寄件者: 寄件日期: 收件者:	New Design Consultancy < 2024年11月05日星期三 18:04	>
收什看: 主旨: 附件:	Fw: Application No. A/NE-LT/772 林村圖-SECTION 16.pdf	
類別:	Internet Email

In response to Water supplies Department (WSD)'s comment, the applicant advise that:

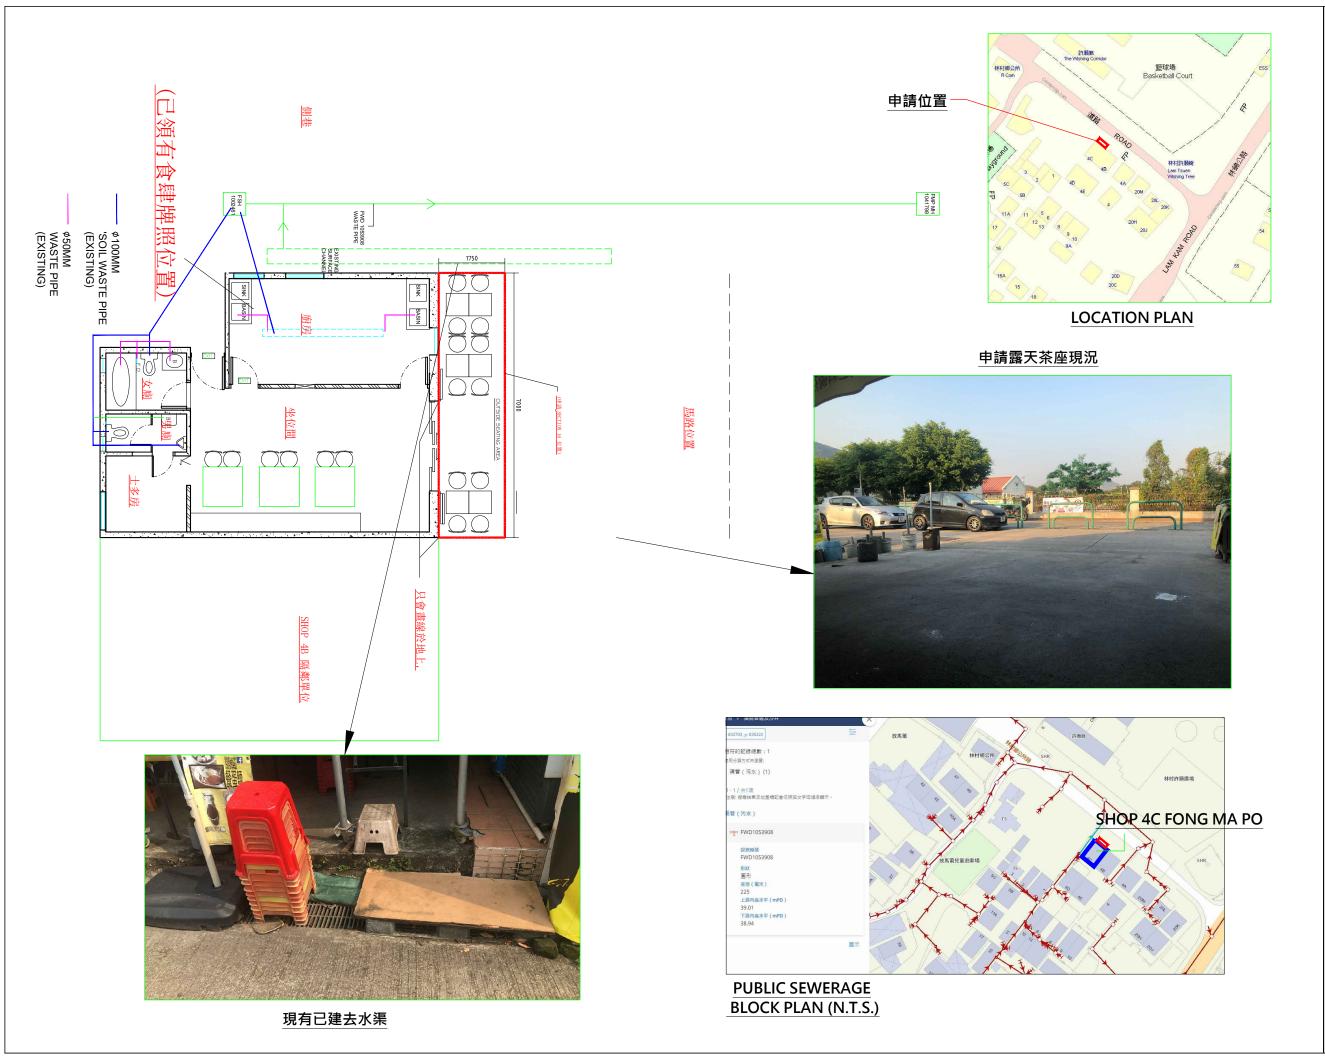
In response to FEHD's Comment, the applicant advise that;

1) The application site will reduce from 3.5m to 1.75 m (total 12.25 sqm) and the width for passageway will be increase. Please see attached plan. Hence, it won't affect the daily operation of the concerned good stalls during New Year Fair.

In response to Land's Department , the applicant provide revised layout plan for further comment.
